Intersection ID: 17597	Main Street: CASTLETON_RD	Cross Street: N_SHARON_AMITY_RD	Location:	W
ADA ID: 8B71138F7810	Ramp Type: PerpDiag	Initial Pass/Fail: Fail	Overall Compliance: No	Severity Score: 31.25

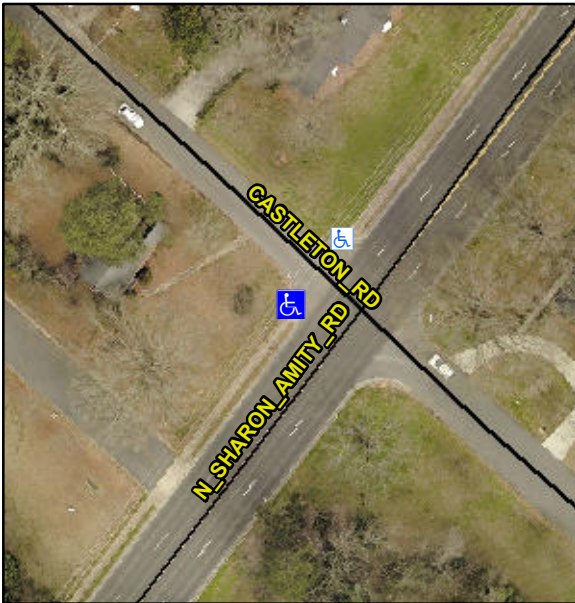
**Not Found, R304.5.1, R304.2.2,
R304.5.3**

Compliance	Description	Data	Compliance	Description	Data
N/A	Ramp Length (in)	58.0	No	Ramp Slope (%)	8.5
No	Ramp Width (in)	32.0	No	Ramp XSlope (%)	3.2
N/A	Flare Type LT	N/A	N/A	Flare Type RT	N/A
N/A	Flare Slope LT (%)	N/A	N/A	Flare Slope RT (%)	N/A
N/A	Flare Traversable LT?	N/A	N/A	Flare Traversable RT?	N/A
N/A	Landing Length (in)	N/A	N/A	DWS Provided?	N/A
N/A	Landing Width (in)	N/A	N/A	DWS Contrast?	N/A
N/A	Landing Slope (%)	N/A	N/A	DWS Length (in)	N/A
N/A	Landing X Slope (%)	N/A	N/A	DWS Full Width?	N/A
N/A	Landing Curb? (Y/N)	N/A	N/A	DWS Offset (in)	N/A
N/A	Shared Landing?	N/A			
N/A	Gutter Ponding?	N/A	N/A	Gutter Slope (%)	N/A
N/A	Gutter Lip Ht (in)	N/A	N/A	Gutter X Slope (%)	N/A
N/A	Painted X Walk1?	No	N/A	Painted X Walk2?	No
	X Walk 1 Direction	To SE		X Walk 2 Direction	To NE
N/A	X Walk 1 Width (in)	N/A	N/A	X Walk 2 Width (in)	N/A
	X Walk 1 Slope (%)	3.6		X Walk 2 Slope (%)	7.1
	X Walk 1 X Slope (%)	2.9		X Walk 2 X Slope (%)	0.8

Remove & Replace Curb Ramp With Two New Directional Ramps or Equivalent.
